REF: M-4-23
DATE: February 12, 2026

Request - Amending TMC Chapters 743, 1103, 1104, 1107, & 1116 Relating to the Downtown Parking Lot Review and Improvement Advisory Committee (DPLRIAC) and Surface Parking Lots in the Downtown and Warehouse Districts.

Applicant - Toledo City Plan Commission
One Government Center, Suite 1620
Toledo, OH 43604

Exhibit “A”

1103.1500 Warehouse UNO District.**1103.1519 Design Standards – Surface Parking Lots.**

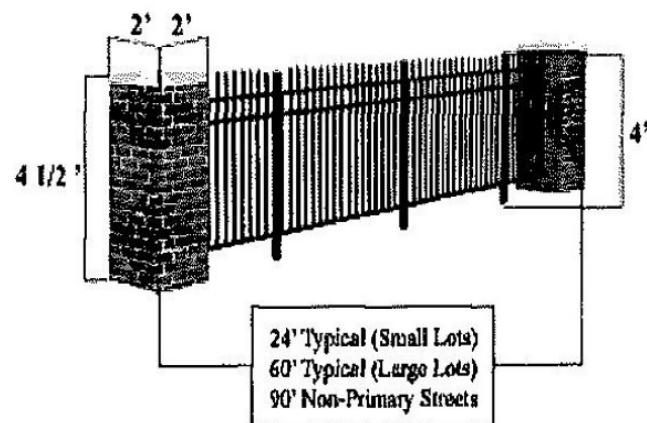
- ~~1. Sections: Standard sections are 6' wide.~~

- ~~2. Pickets: Commercial 3/4" square x .055~~
- ~~3. Spacing between Pickets: Commercial standard 3-5/8" and optional 1-1/2"~~
- ~~4. Fasteners: Stainless steel~~
